ADDENDUM NO.: 2

DATE OF ADDENDUM: JUNE 2, 2015

**JOYNER HALL
NORTHWESTERN CONNECTICUT COMMUNITY COLLEGE
BI – CTC – 427**

SCALE: 1 1/2"=1'-0" REVISED DETAIL 3/A-350

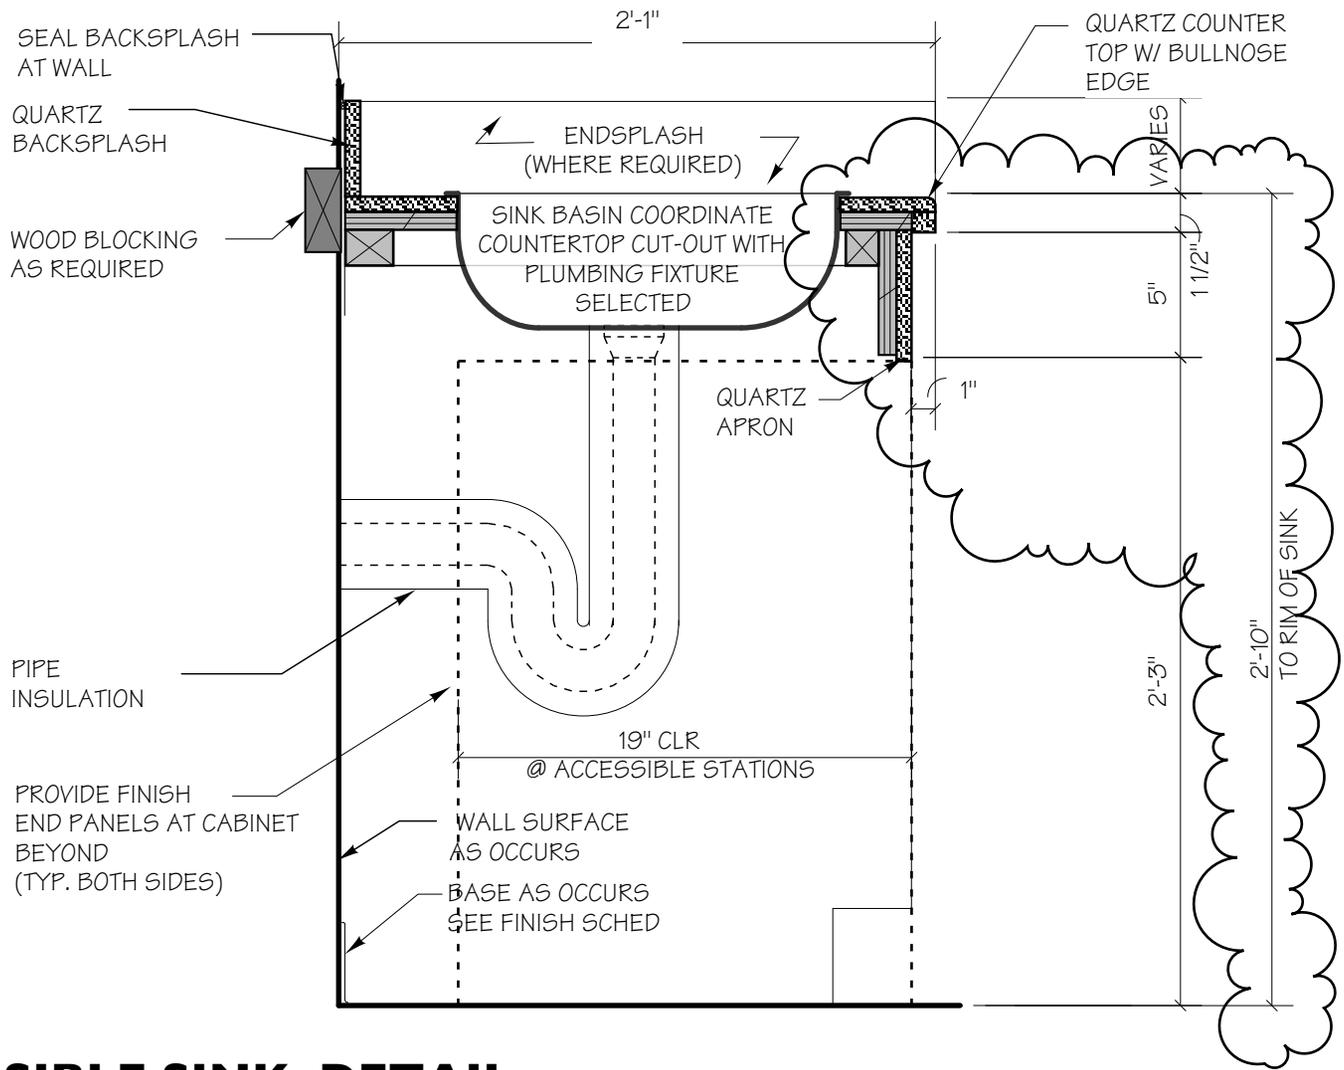
Clarification: The dimension from the floor to the highest point on rim has been revised for counter top with drop in sink detail 3/A-350. Refer to ADA-01 attached to this addendum.

SCALE: 1/4" = 1'-0" REVISED DETAIL 9/A-502

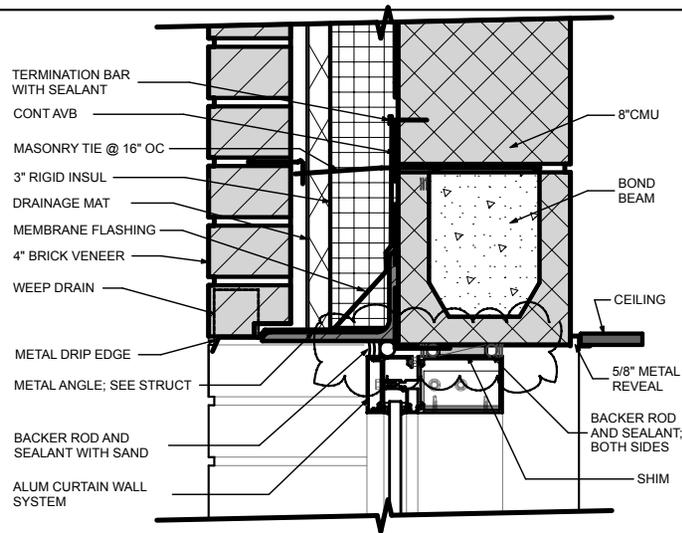
Clarification: Detail 9/A-502 dimension 1'-11" is incorrectly placed. Note has been relocated for clarification. Refer to ADA-21 attached to this addendum.

REVISED 4/A-612.1

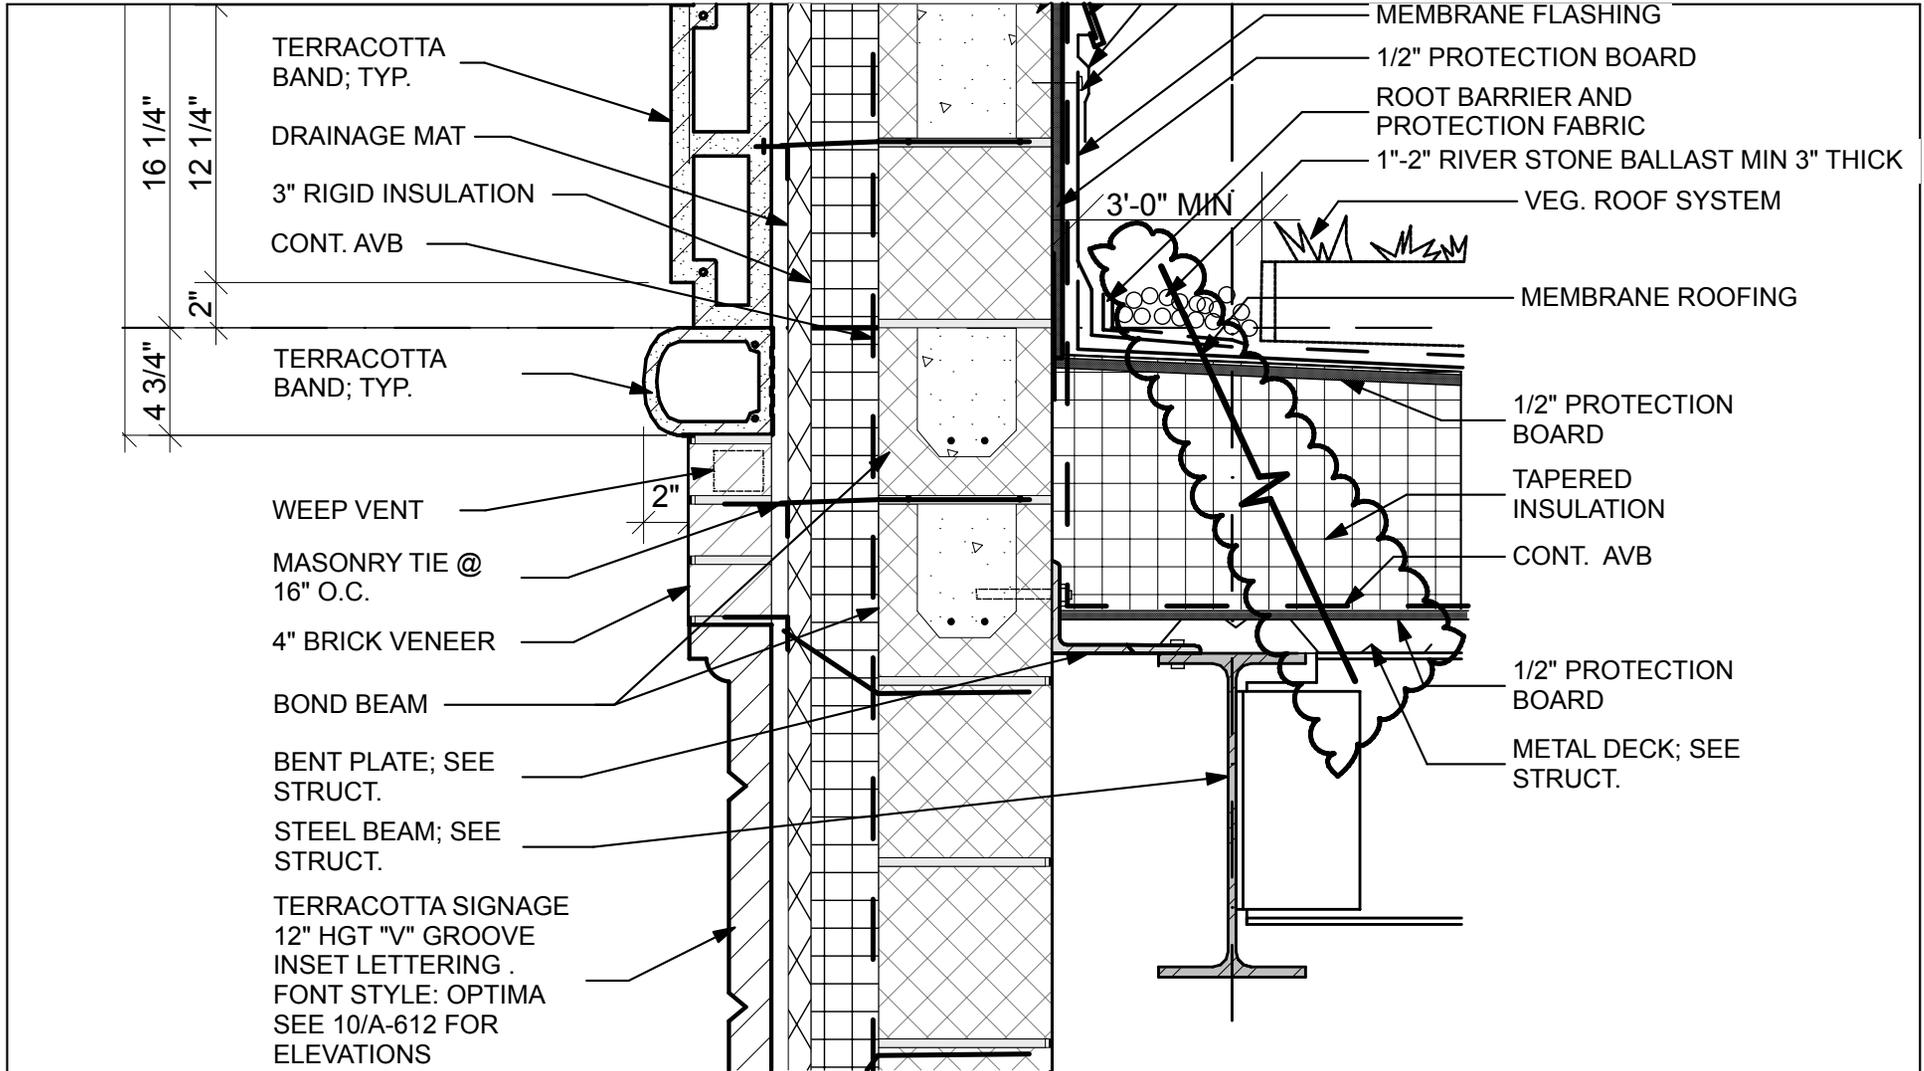
Clarification: Break-line has been added to 4/A-612.1 for clarification. Refer to ADA-23 attached to this addendum.

REVISED DETAIL 6/A-620

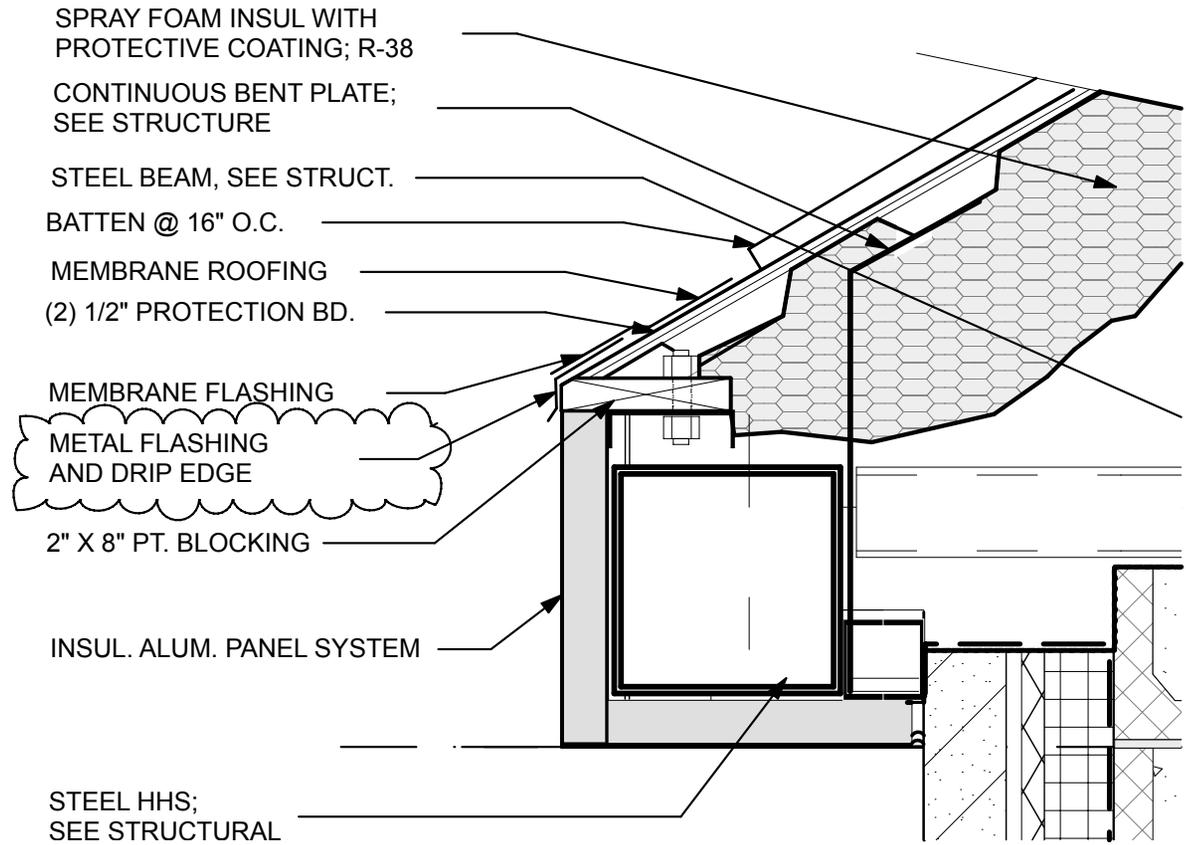
Clarification: Detail bubble referring to typical detail 1/A-623 has been added to detail 1,3,4&6/A-620 to note the drip edge. Refer to ADA-24, ADA-49, ADA-50 and ADA-51 attached to this addendum.

REVISED DETAIL 2/A-623

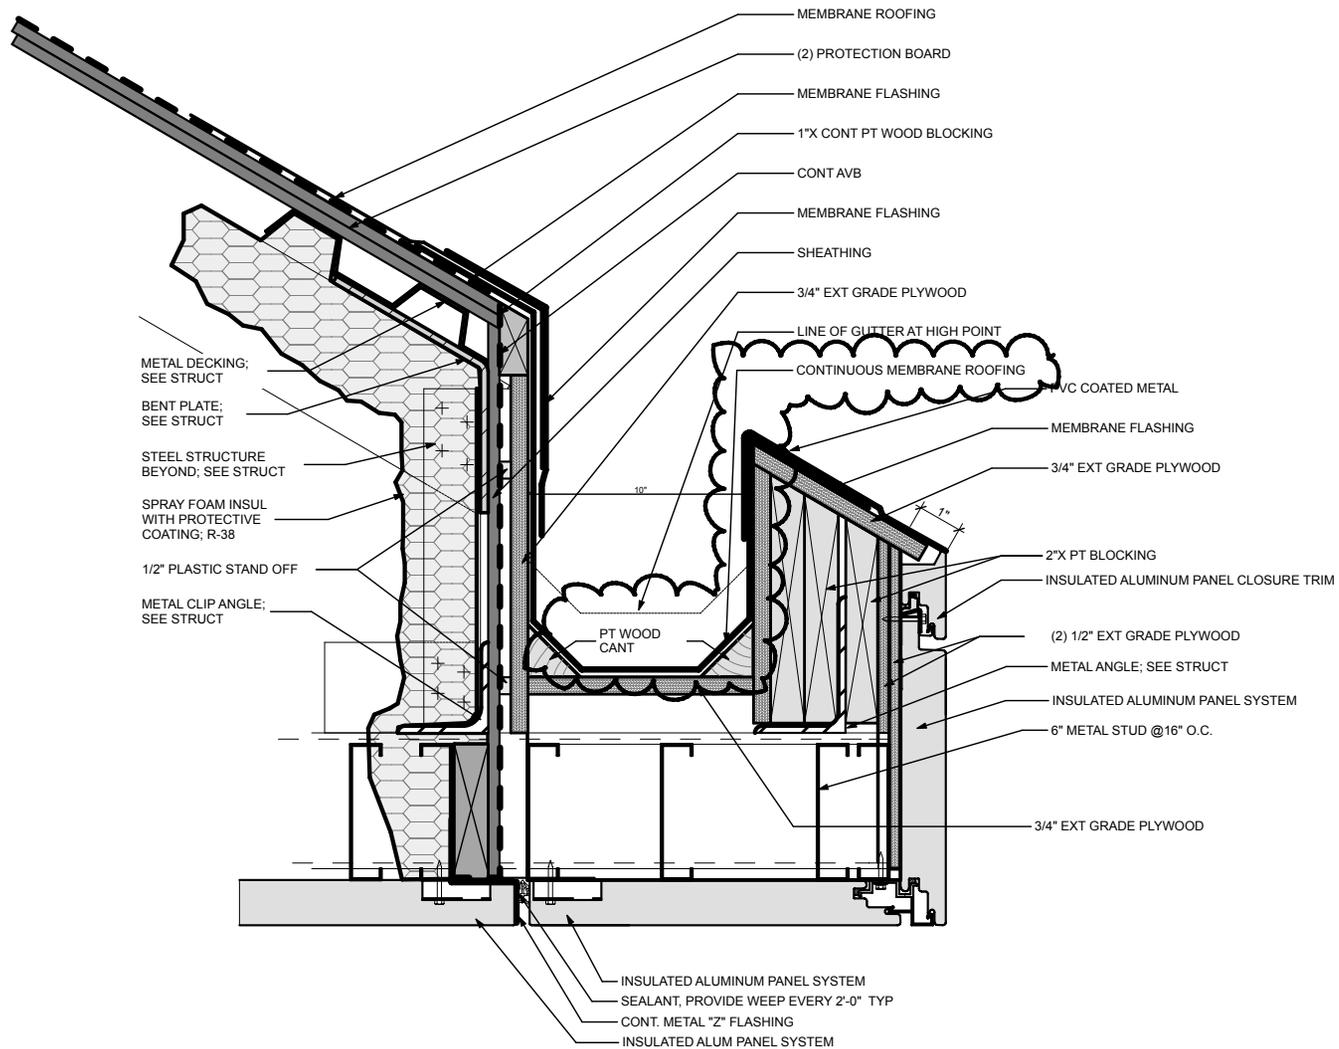
Question: "Reference Detail 2/A-621. What is the built-in gutter lined with?" RESPONSE: Built-in gutters are lined with roof membrane, typical for all built-in gutters. Note has been added for clarification. . Refer to sketch ADA-26 attached to this addendum.

Clarification: Pressure treated cants and gutter material have been noted in detail 2/A-623 for clarification. Refer to ADA-26 attached to this addendum.

REVISED DETAIL 5/A-623

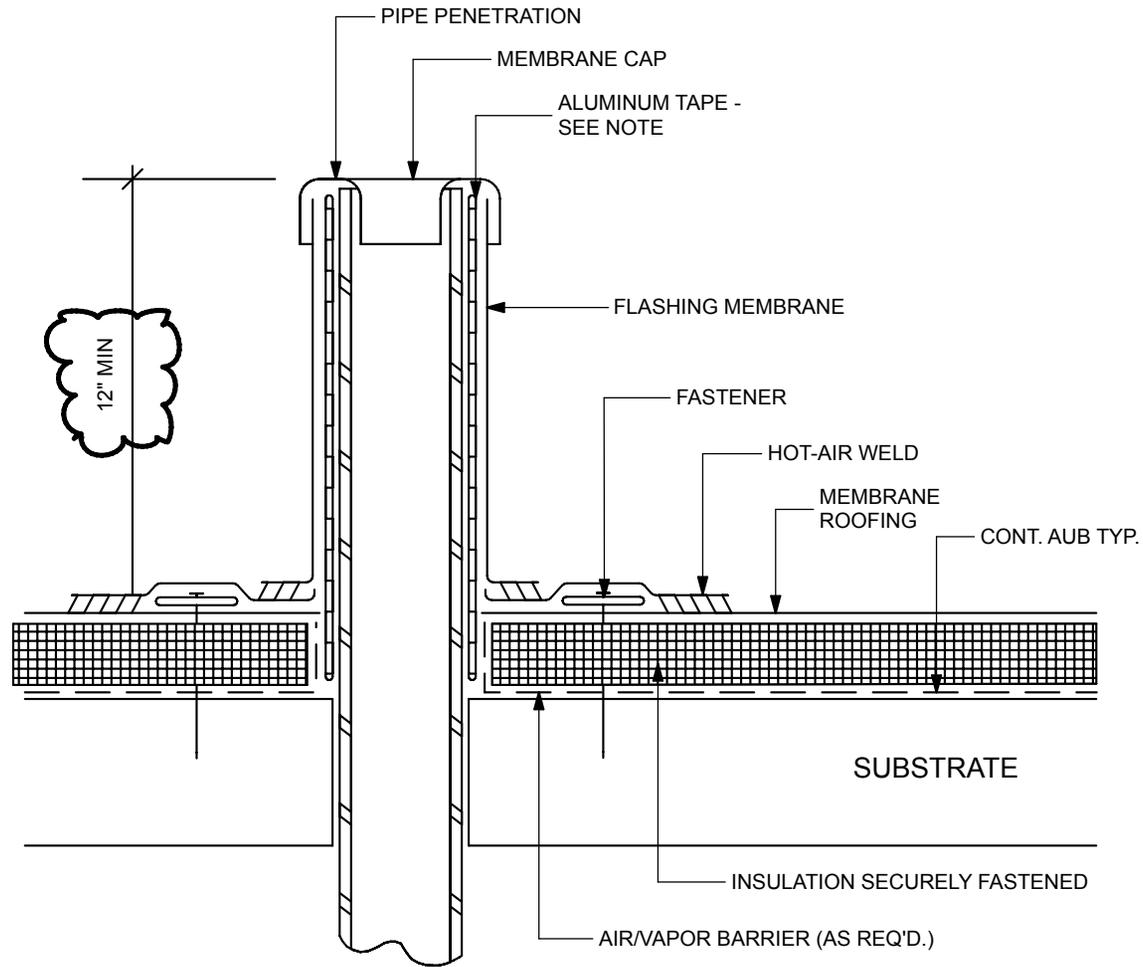
Clarification: Dimension for vent pipe extension shown on detail 5/A-623 have been corrected to comply with code. Refer to ADA-28 attached to this addendum.

A 1 UPPER LEVEL THRESHOLD @ DOOR 201A
 ADA-01 SCALE: 1 1/2" = 1'-0"

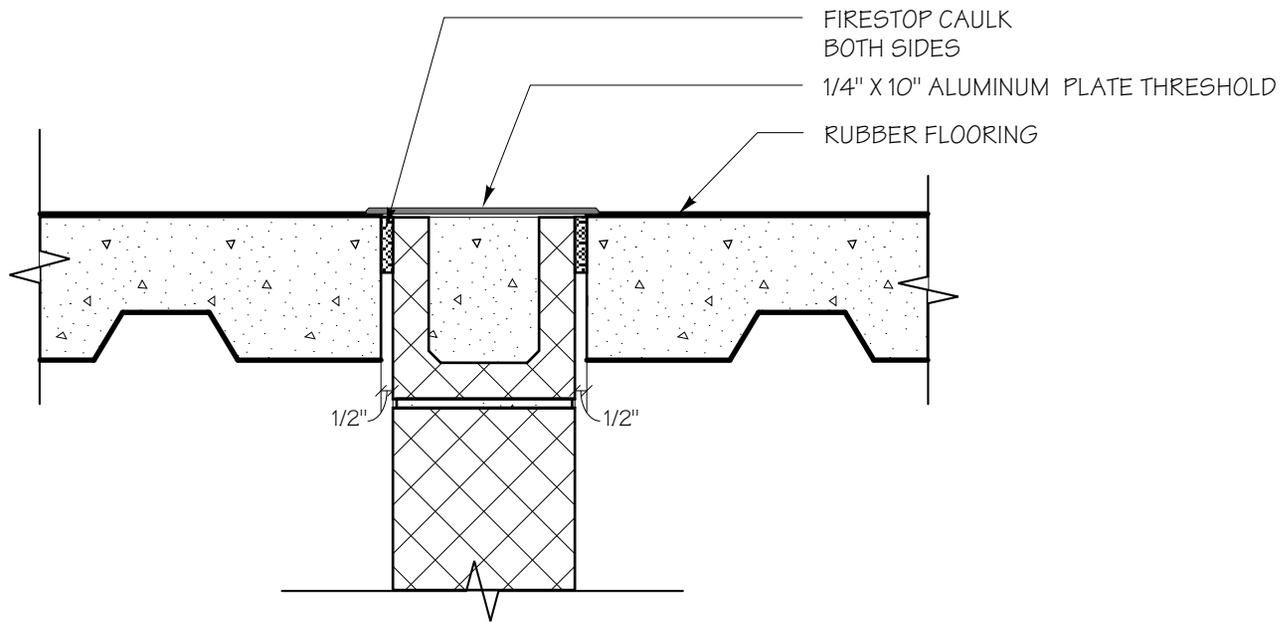
Clarification: Detail added to clarify threshold at door 201A. Refer to sketch ADA-29 attached to this addendum.

REVISED DETAIL 2/A-604

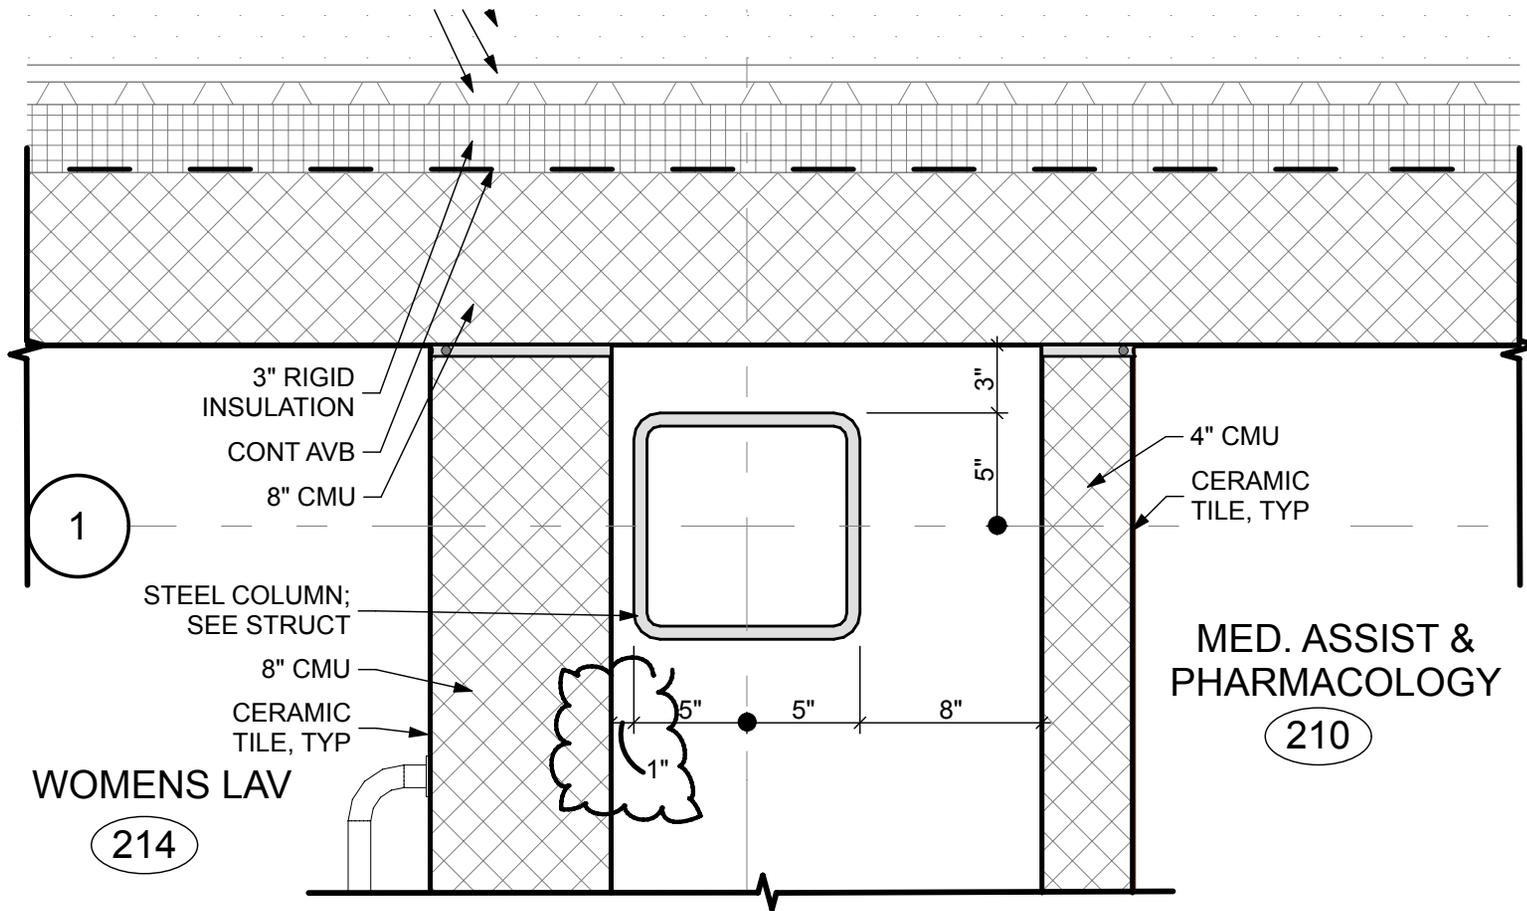
Clarification: Detail 2/A-604 at Centerline E was revised to show the additional dimension of the chase wall for clarification. Refer to ADA-33 attached to this addendum.
